## **IN THE DRAWINGS**

## **REMARKS**

FIG. 2C

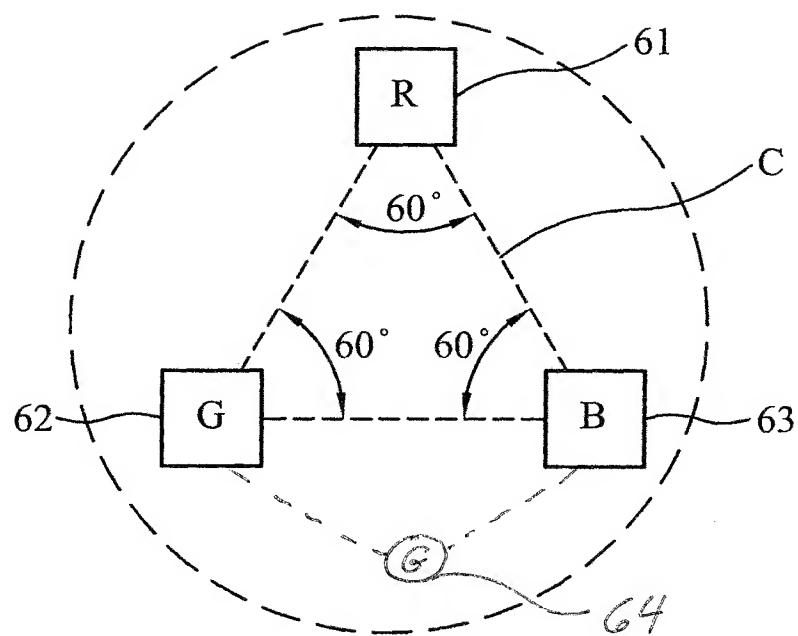
FIG. 2C is amended to add the adjacent light emitting diode 64.

FIG. 3A

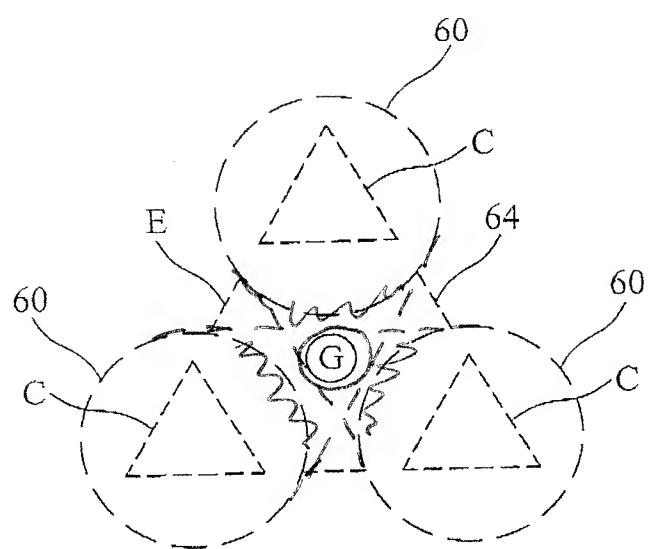
FIG. 3A is amended to modify lines to illustrate the grouping of the first, second, and third light emitting diode (61, 62, 63) and the adjacent light emitting diode.

FIG. 3B

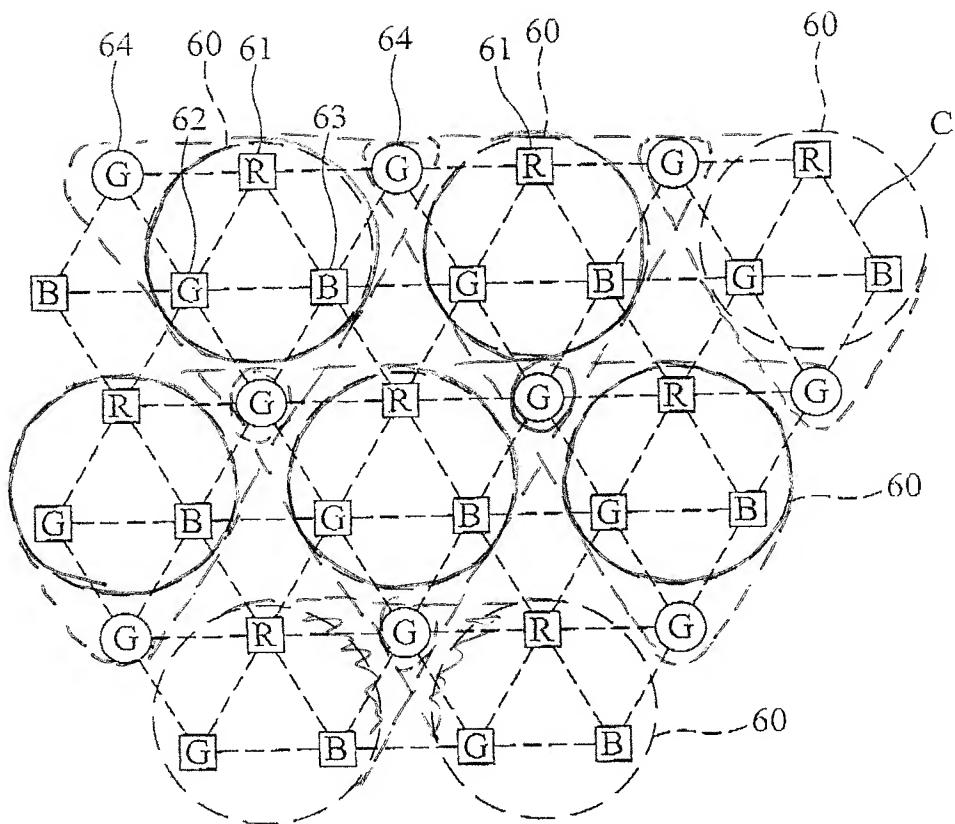
FIG. 3B is amended to modify lines to illustrate the grouping of the first, second, and third light emitting diode (61, 62, 63) and adjacent light emitting diodes in a cell structure.
